High School in Jerrabomberra

Response to Submissions and SDRP

30.03.2022

BUILDING VOLUME RATIONALE | ACCESS AND PERMEABILITY

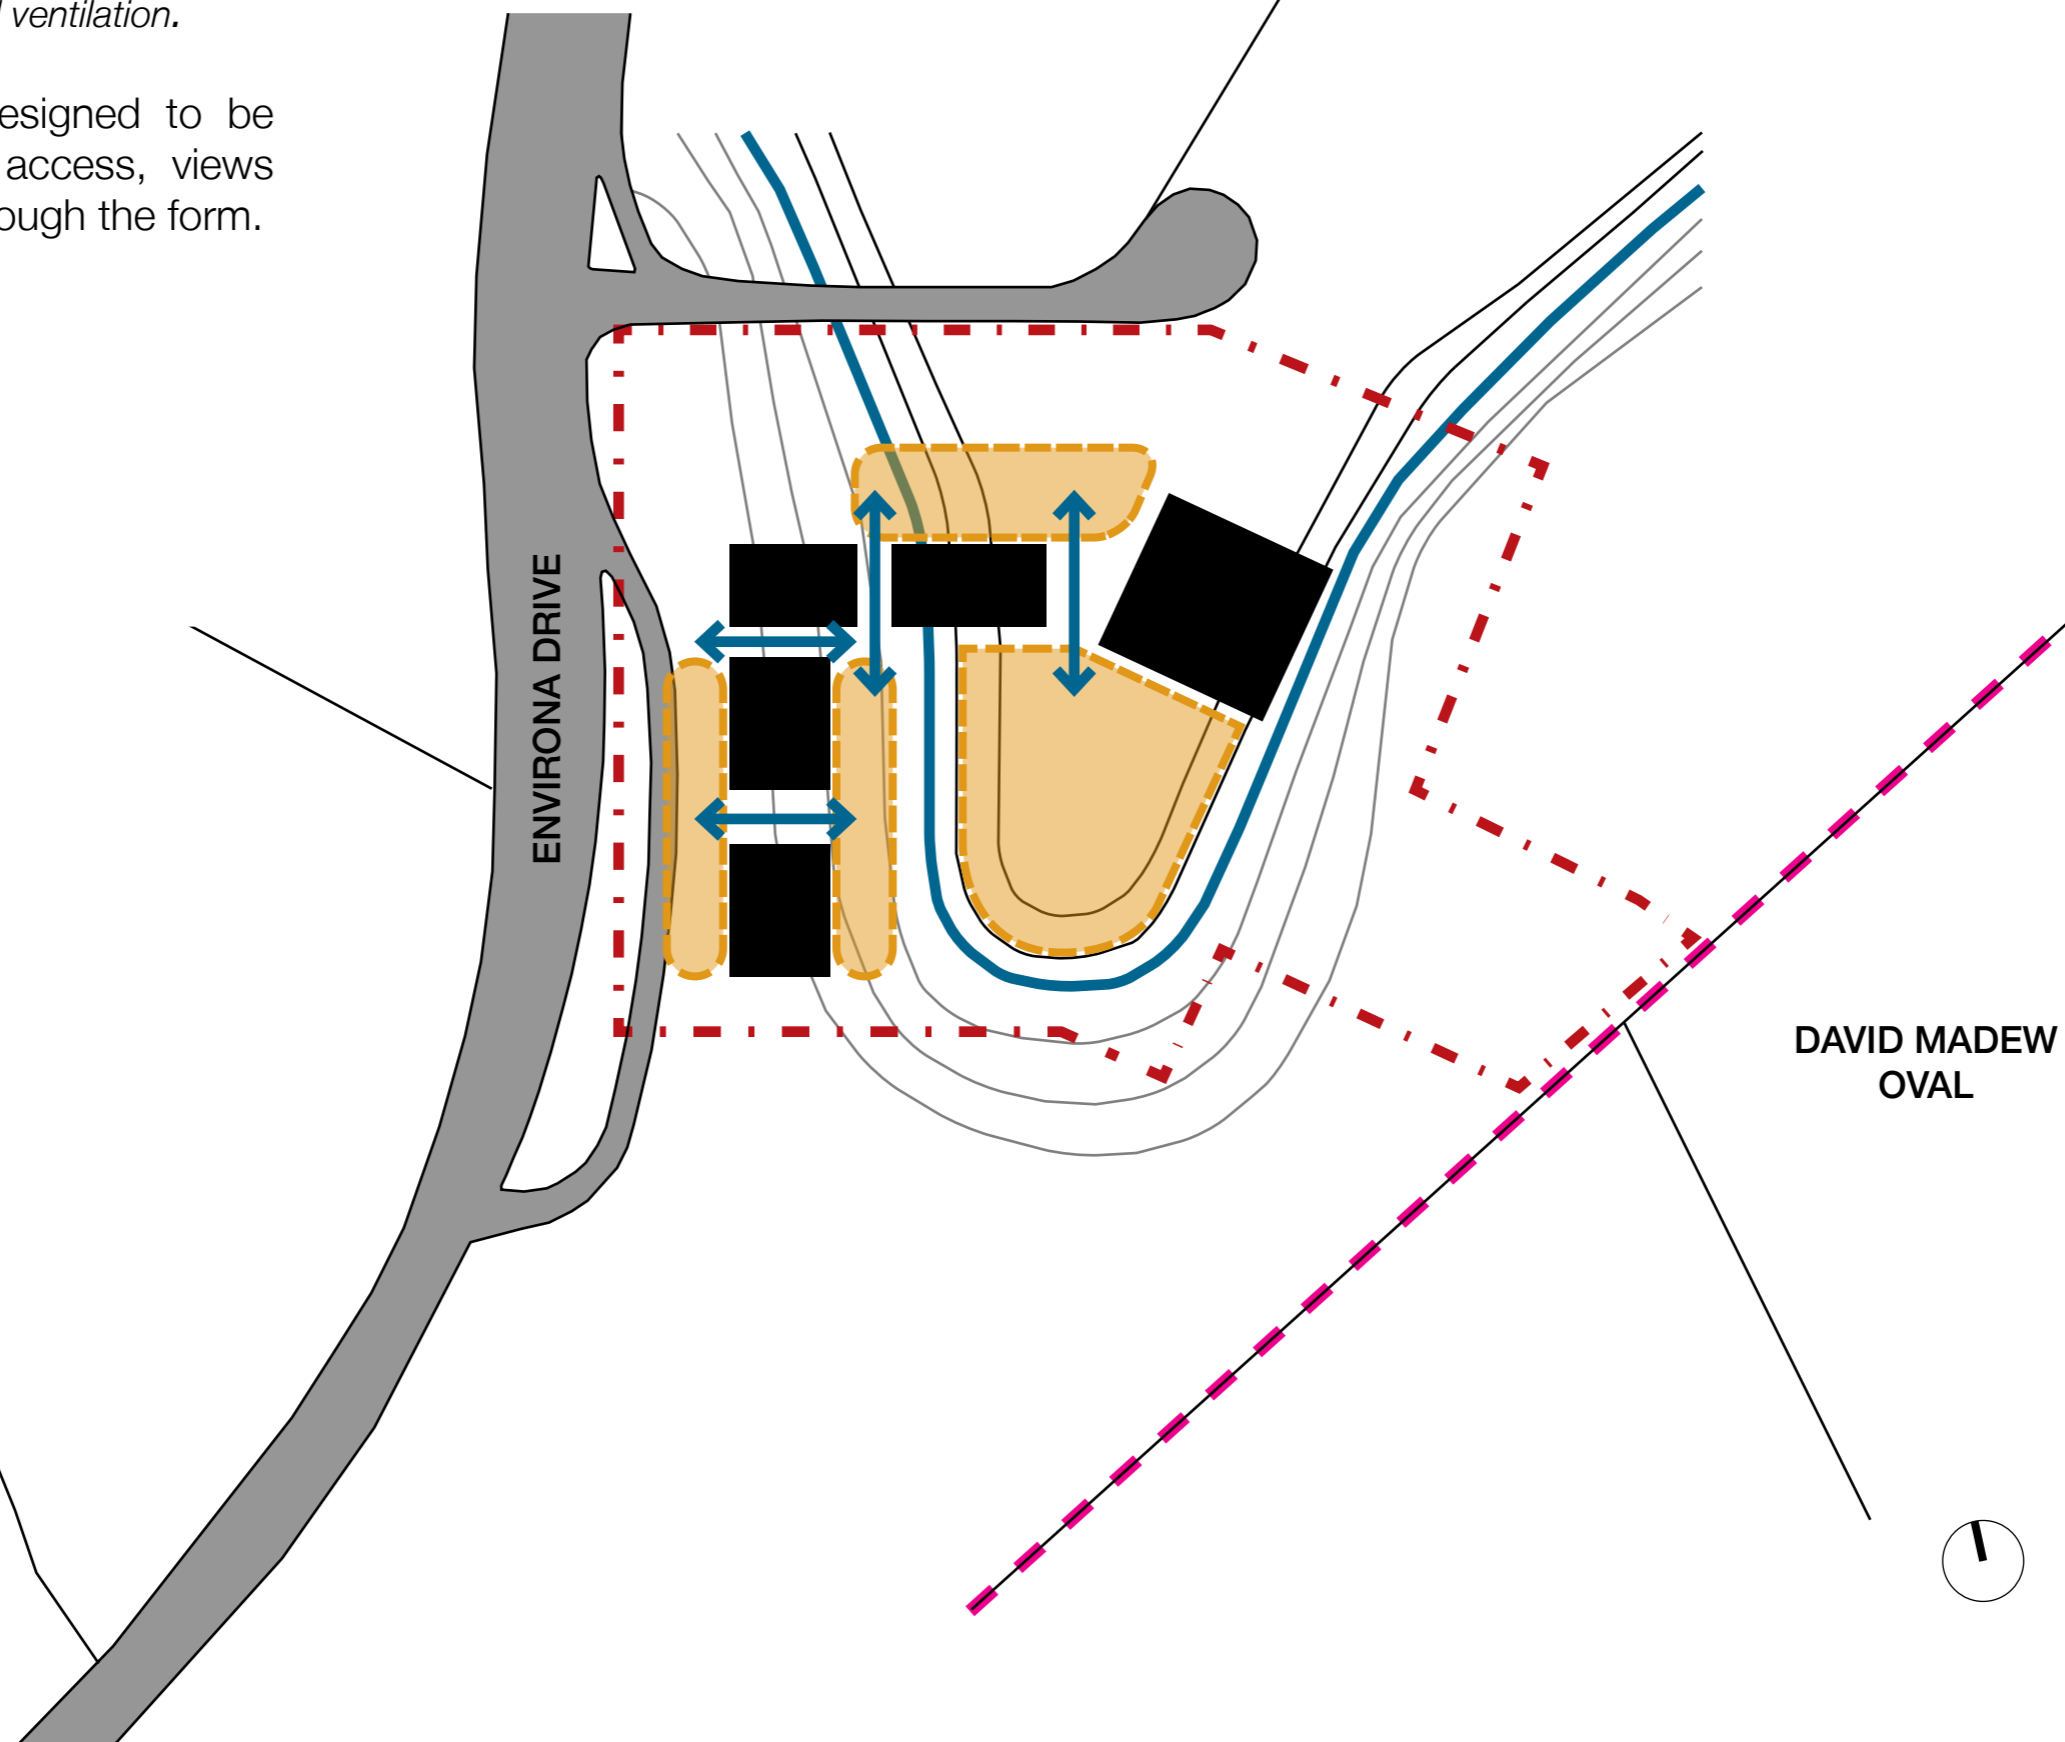
Recommendations 11 and 12a – opportunities must be pursued to articulate the volume of Building A along Envirova Drive to reduce the visual bulk and allow for more opportunities for natural ventilation.

- The volume is designed to be porous, allowing access, views and ventilation through the form.

BUILDING VOLUME RATIONALE | REDUCTION OF VISUAL BULK + CROSS VENTILATION

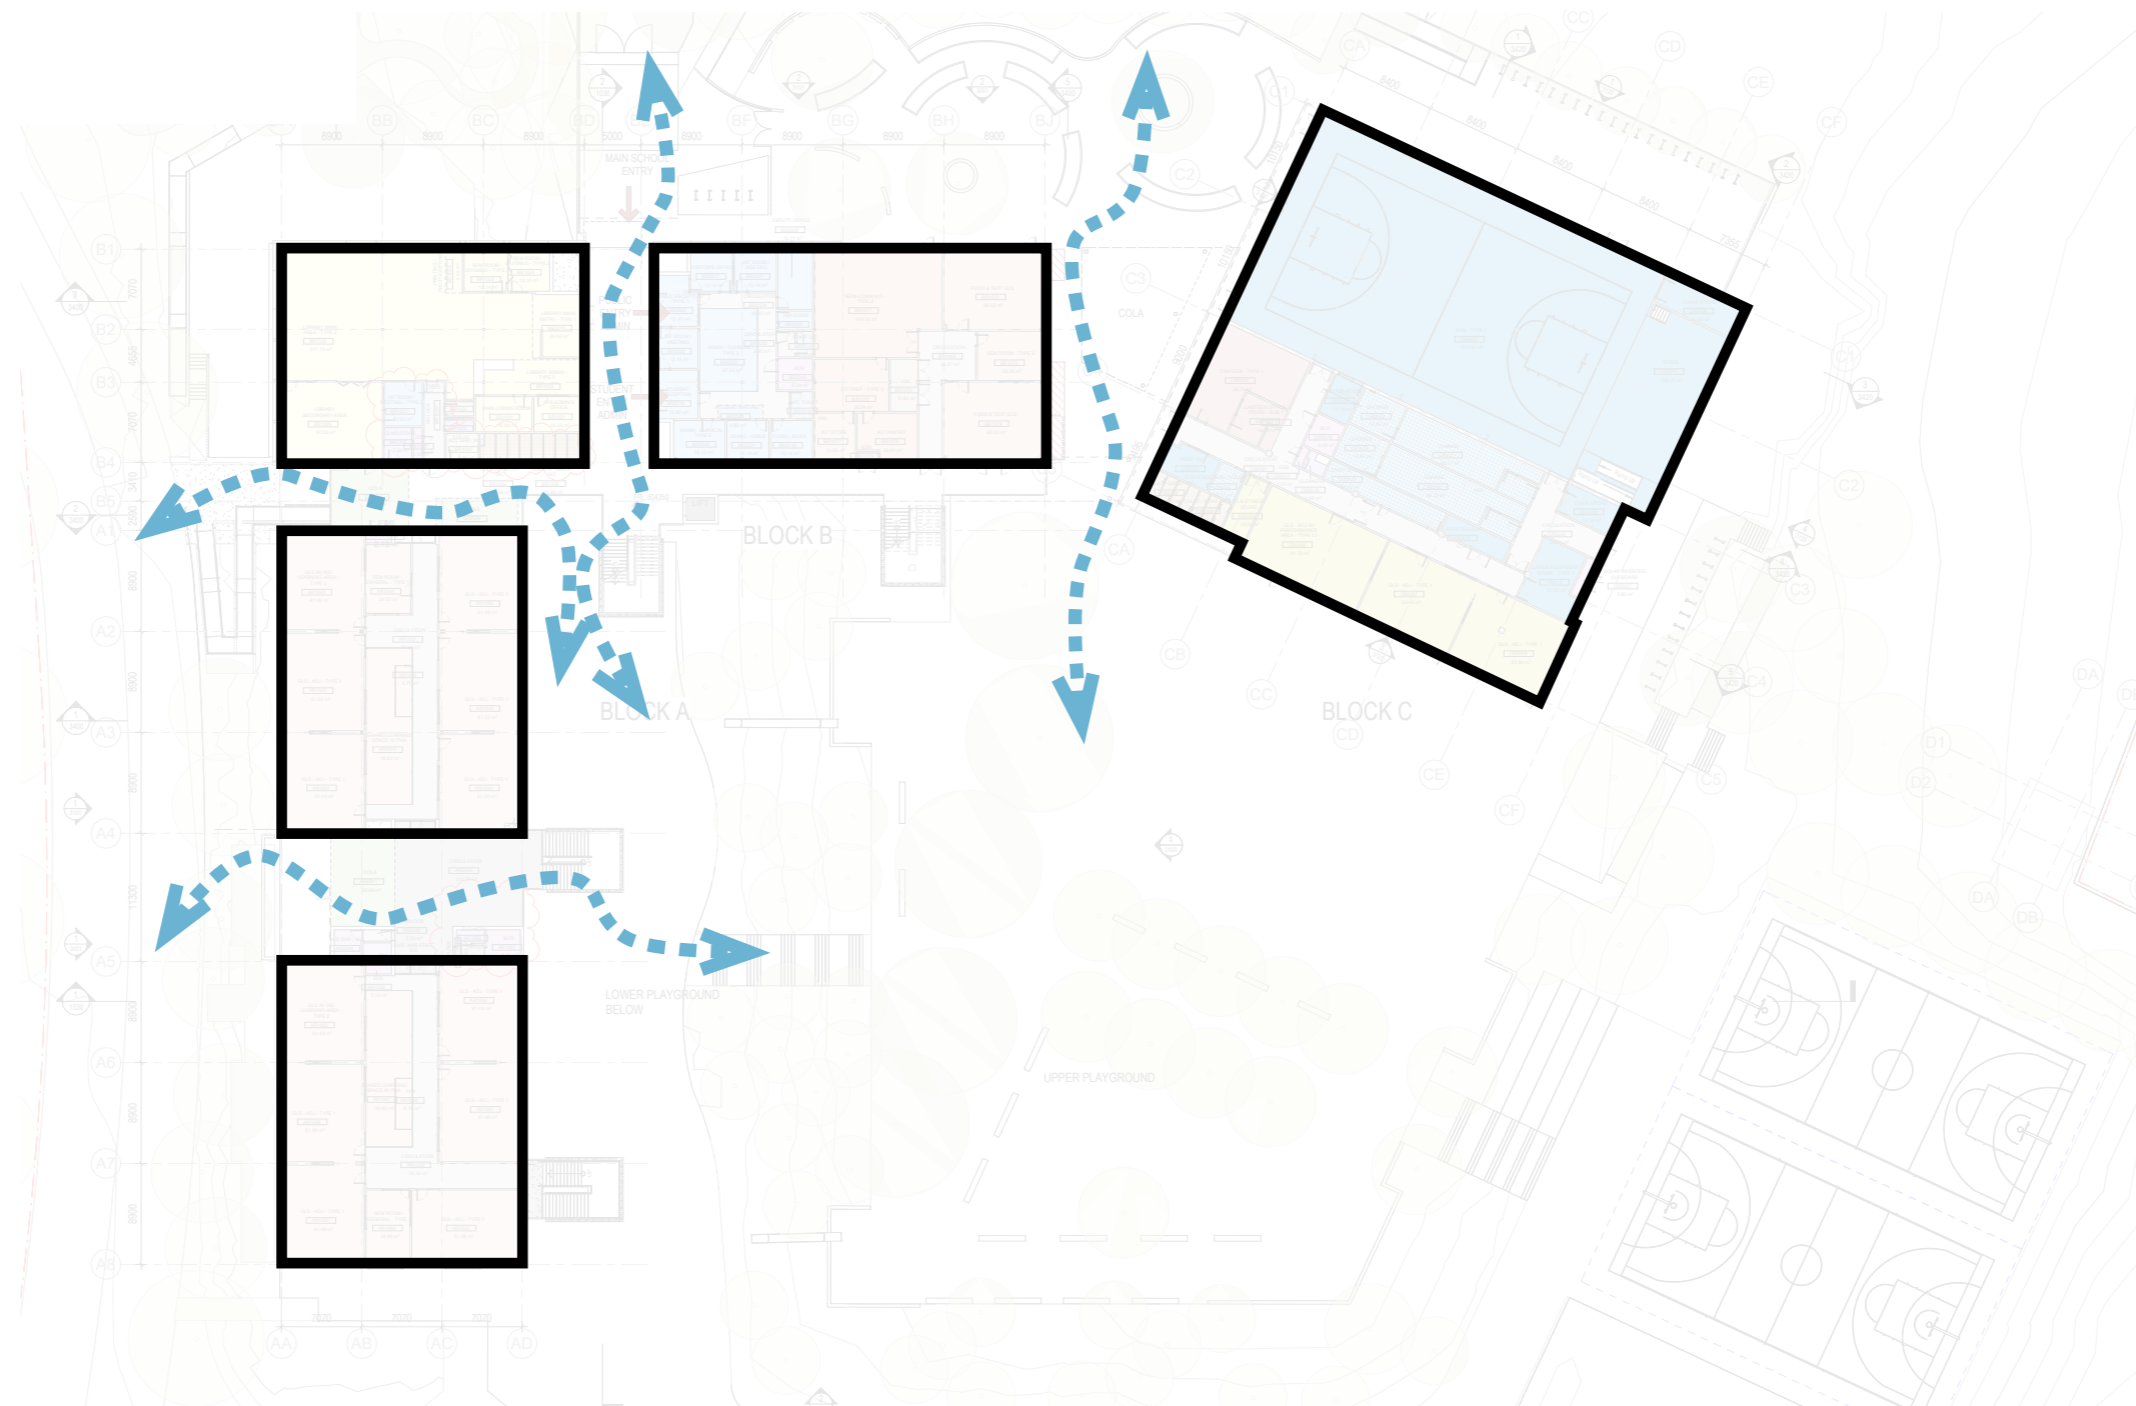
Recommendations 11 and 12a – opportunities must be pursued to articulate the volume of Building A along Environa Drive to reduce the visual bulk and allow for more opportunities for natural ventilation.

- The building volumes are separated to allow cross ventilation and porosity.

BUILDING VOLUME RATIONALE | OPPORTUNITIES FOR NATURAL VENTILATION

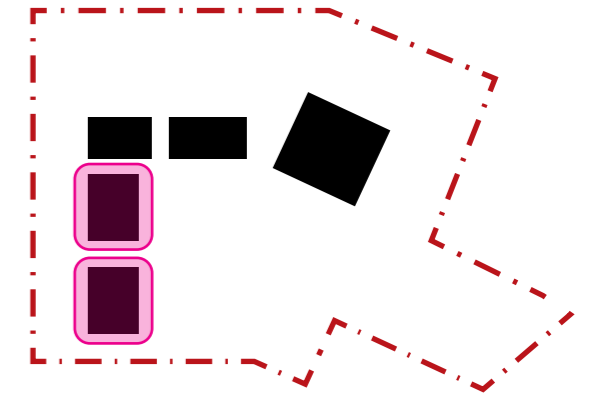
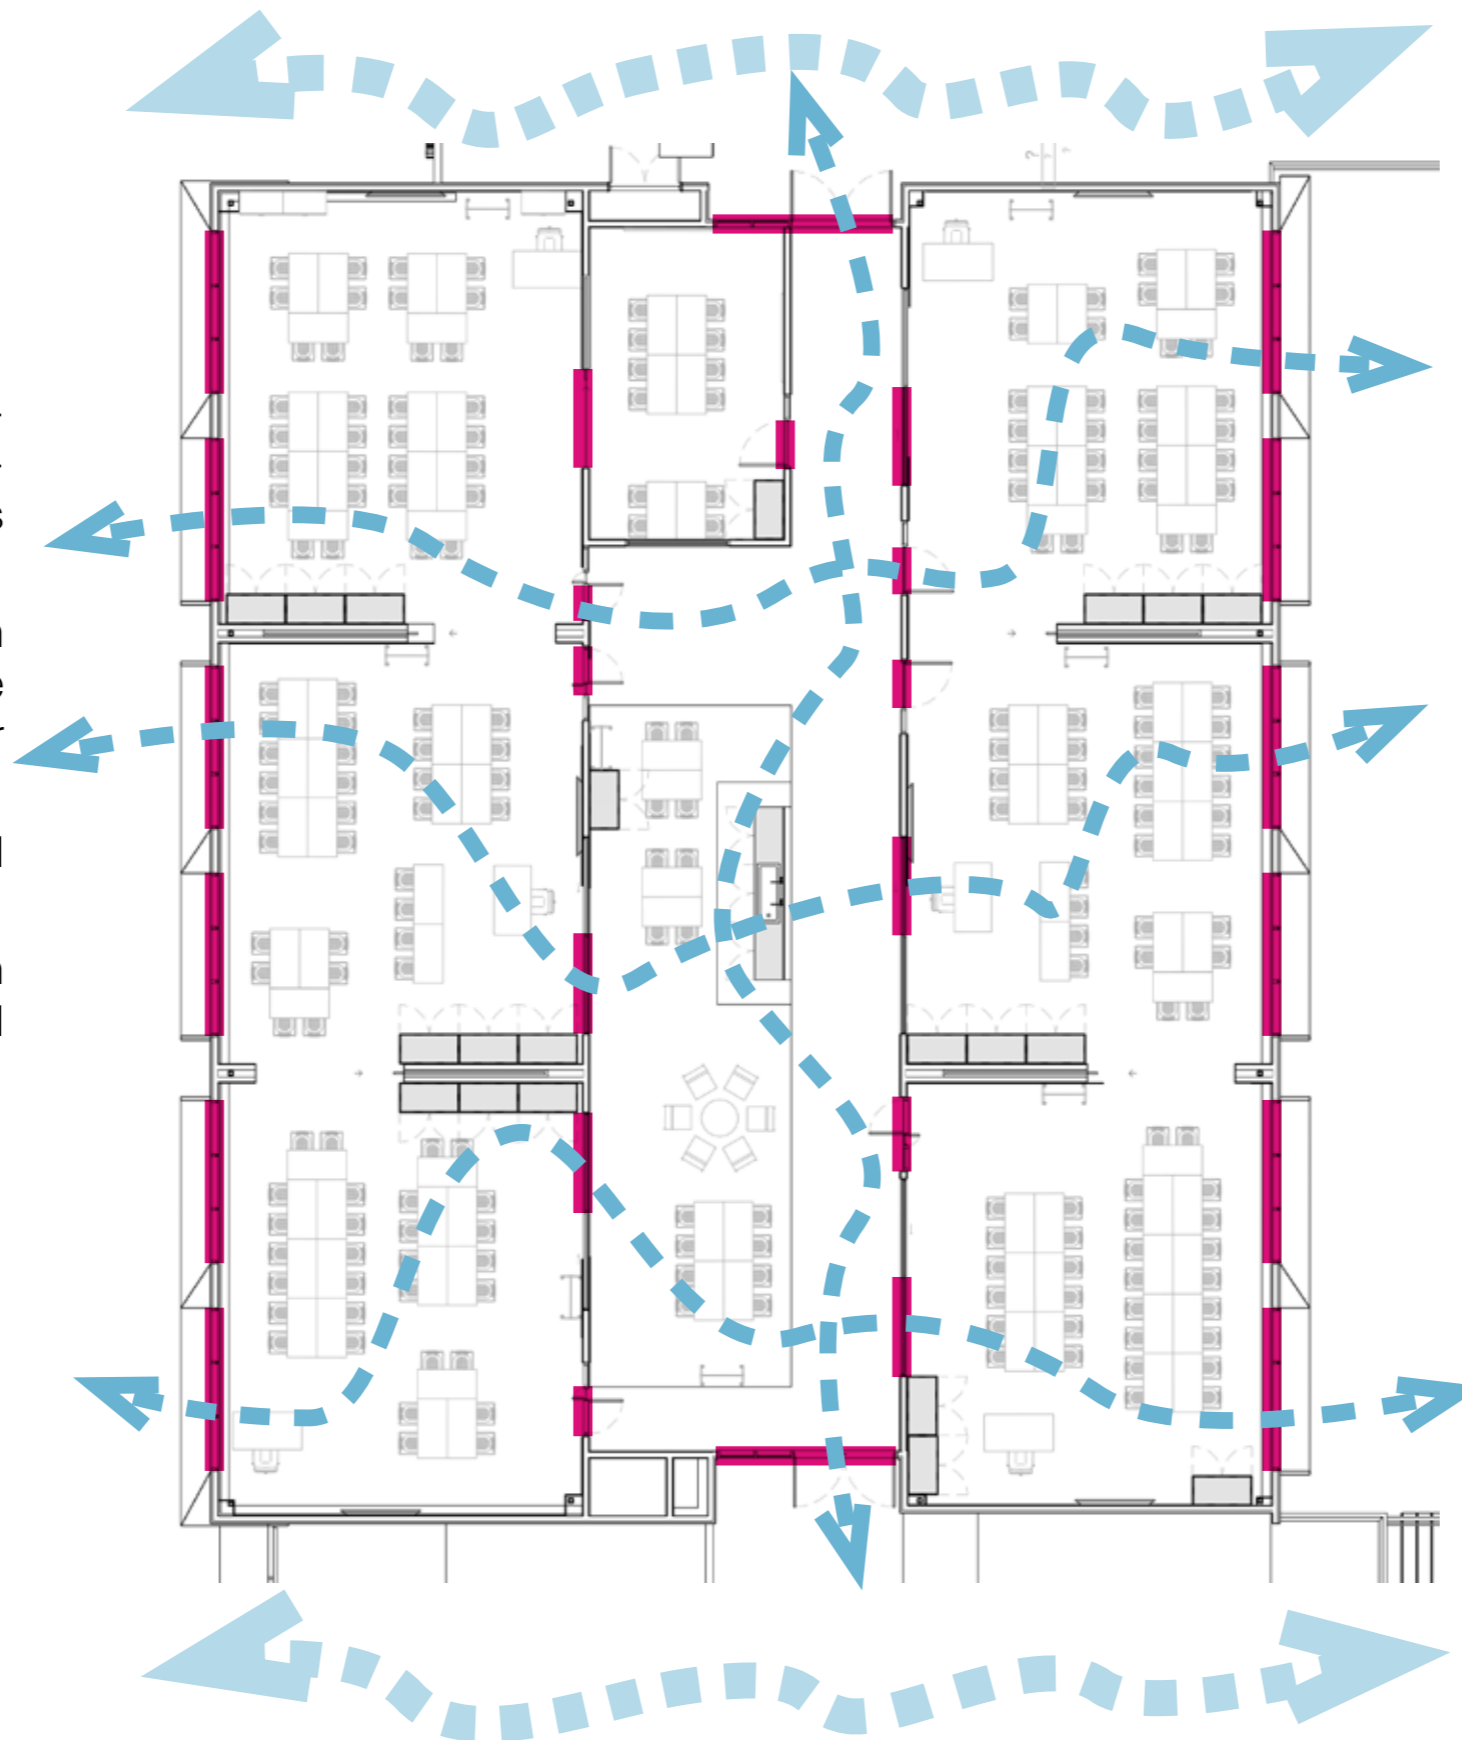
Recommendations 11 and 12a – opportunities must be pursued to articulate the volume of Building A along Environa Drive to reduce the visual bulk and allow for more opportunities for natural ventilation.

- The users can modify their environment by manipulating openings which provide opportunities for natural ventilation.
- Cross ventilation occurs through the learning commons via the open circulation nodes at either end of the hubs
- Operable windows in the external facade allow for air flow
- Cross ventilation occurs through external openings and internal partitions
